Proposal for Supplement 2 to the 06 series of amendments of UN Regulation No. 22 (Protective helmets)

Submitted by the experts from the [Ad Hoc Group of Interested Experts on Accessories for Protective Helmets under UN Regulation No.22 (APH-UNREG22)]

The text reproduced below was prepared Submitted by the experts from the [Ad Hoc Group of Interested Experts on Accessories for Protective Helmets under UN Regulation No.22] aiming to introduce some corrigendum to the approved proposal. Modifications to document ECE/TRANS/WP.29/2021/24e are marked in bold for new or strikethrough for deleted characters.

Example of the arrangement of the approval mark for a universal accessory that will use two helmet locations

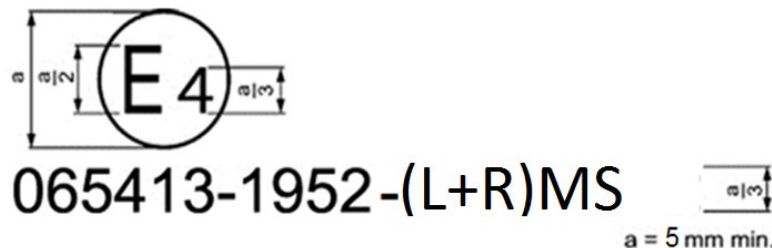
Annex 2C, amend to read:

“ Annex 2C **Example of the arrangement of the approval mark for an accessory**

The above approval mark affixed to a universal accessory shows that the universal-accessory type concerned has been approved in the Netherlands (E 4) under approval number 065413. The approval number shows that approval was granted in accordance with the requirements of the Regulation incorporating the 06 series of amendments at the time of approval, that its production batch is 1952 and that is approved for Side and Rear mounting, each mounting position used by one accessory component, and has Microphone and Speakers.

Example of the arrangement of the approval mark for a universal accessory that can use two helmet locations

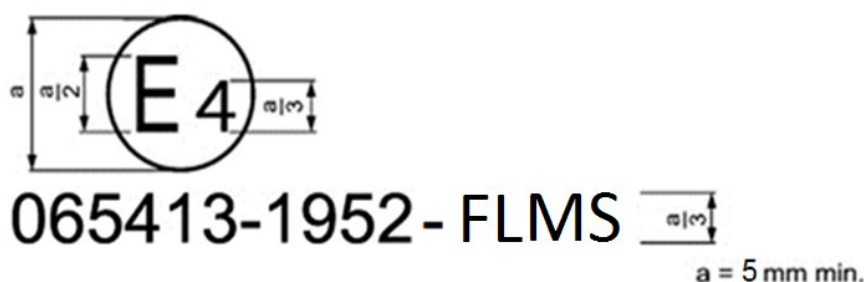
The above approval mark affixed to a universal accessory shows that the universal-accessory type concerned has been approved in the Netherlands (E 4) under approval number 065413. The approval number shows that approval was granted in accordance with the requirements of the Regulation incorporating the 06 series of amendments at the time of approval, that its production batch is 1952 and that is approved for Front or Side mounting and has Microphone and Speakers.

Figure 4

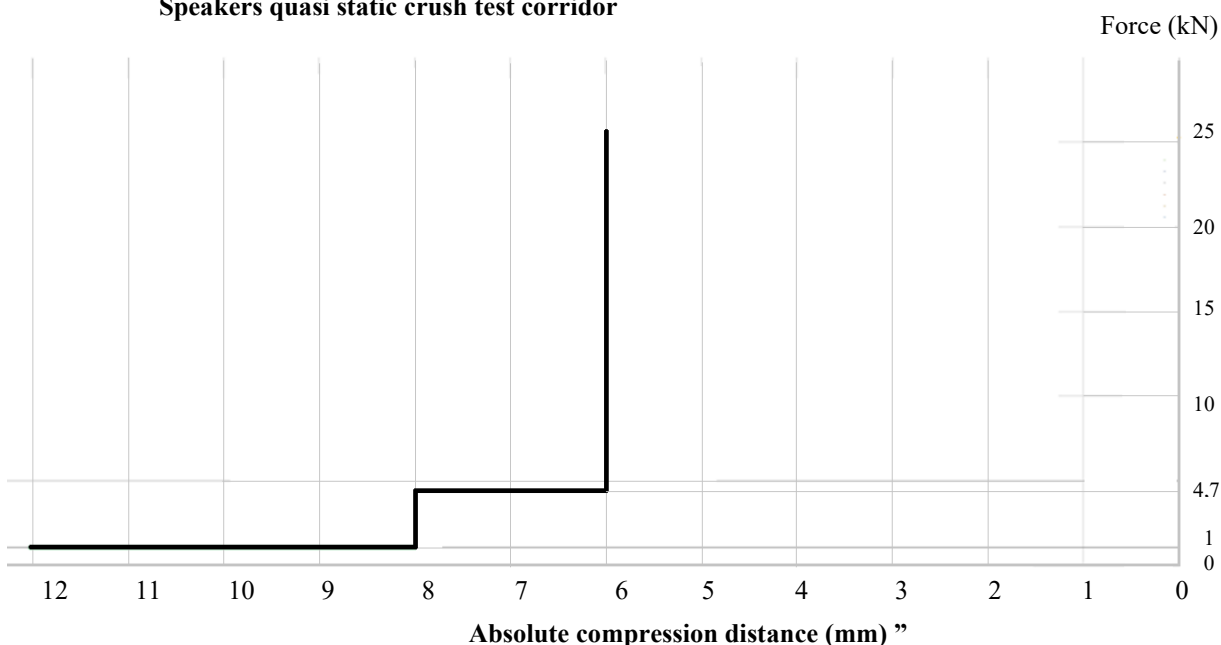
“1.3. Mechanical characterization of the speakers:

1.3.1. The speaker, with a height of more than 5 mm, shall be placed between two parallel plates by means of which a known load can be applied, the surface of the plates shall be large enough to contain a circle of at least 65 mm in diameter.

Start the crush test at a constant speed of 10 mm/min. Record force vs distance at a minimum sampling rate of 10 Hz.

The test ends when the force reaches 10 kN.

The obtained chart for the speakers shall fall below the line defining the upper corridor limit.

Figure 5

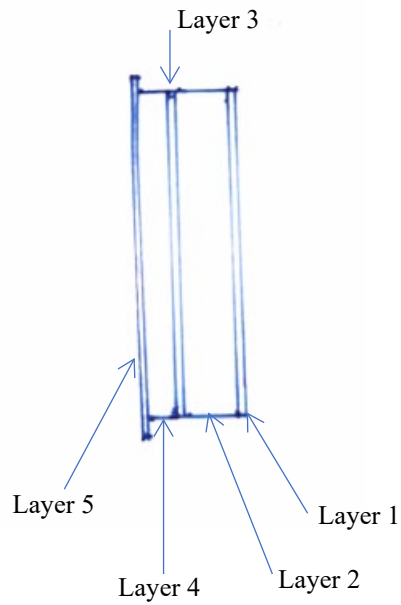
1.4.1 Definition of deformable speaker simulator

The speaker simulator is illustrated in Figure 5 of this annex. The dimensions of the individual components of the speaker simulator are listed separately below. The below layers are a possible construction methodology, alternative possibilities are valid provided that they will fulfill the requirements of 1.4.1.3.

1.4.1.1.2. Layer 2: Outer honeycomb block. Precrushed around 6mm.

1.4.1.1.4. Layer 4: Inner honeycomb block. Precrushed around 6mm.

Diameter: 40 mm/45 mm
Tolerance: +0-1 mm
Thickness: 1 mm ± 0.07 mm
Material: Aluminium 5251/5052 (ISO 209, part 1)

Figure 6

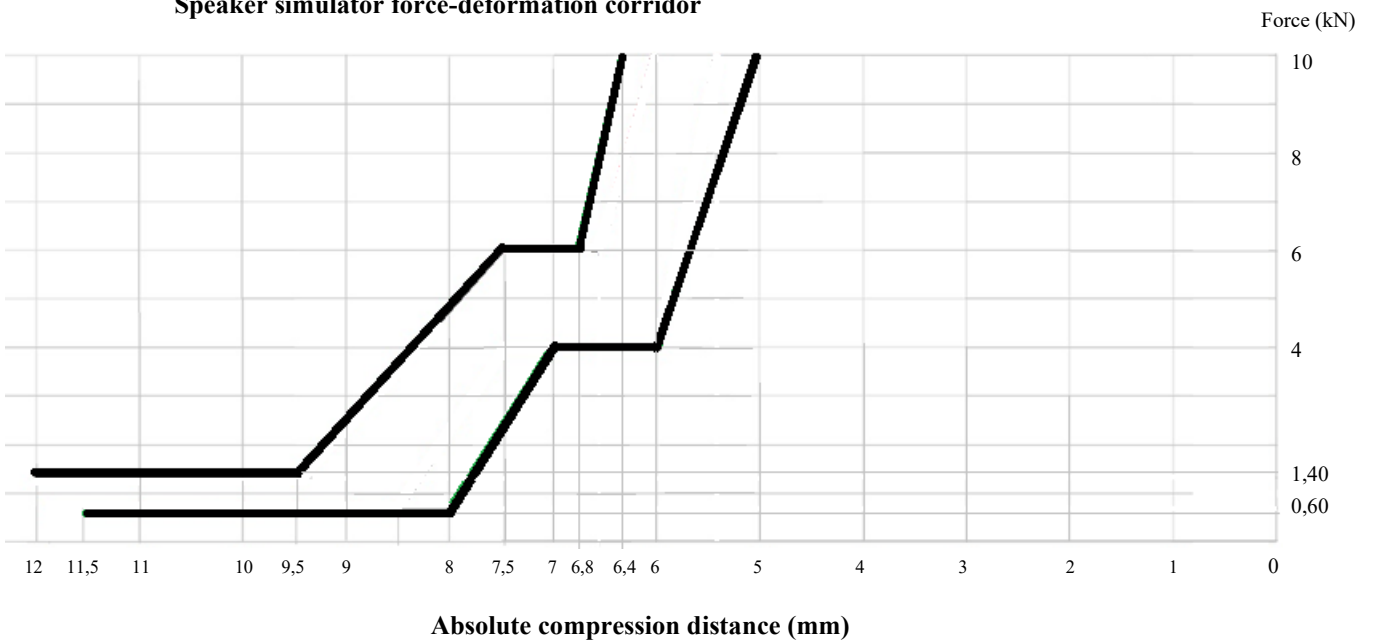
1.4.1.3.1. To ensure the proper behaviour of the speaker simulator, the TS shall ensure that the force-deformation curve will lay within the limits stated in Figure 6.

-
- 1.4.1.3.2. If the force-deformation curve of the simulator pass over the upper corridor limit or below the lower corridor limit by no more than 0,5 mm, the simulator is considered to pass.**

“Figure 7

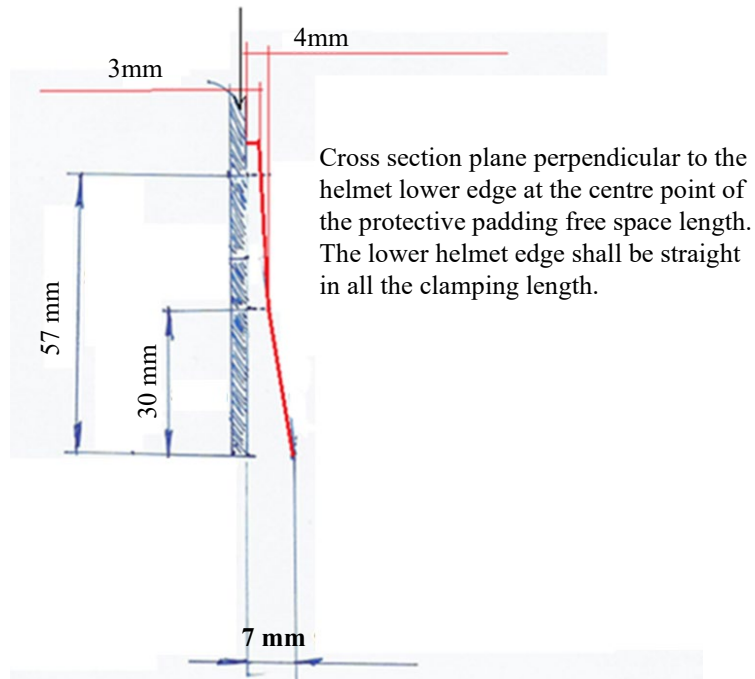
Annex 20, Part 2, paragraph 2.1., change Figure 6 to read:

Free protective padding space for accessories clamping for front and side locations of UA helmets

-
7. Modified definition of speaker simulator to introduce a deformable speaker simulator, which better represents the behaviour of actual speakers, to do a more realistic helmet test.
 8. Modified protective padding free space for accessories clamping because of a typing mistake.
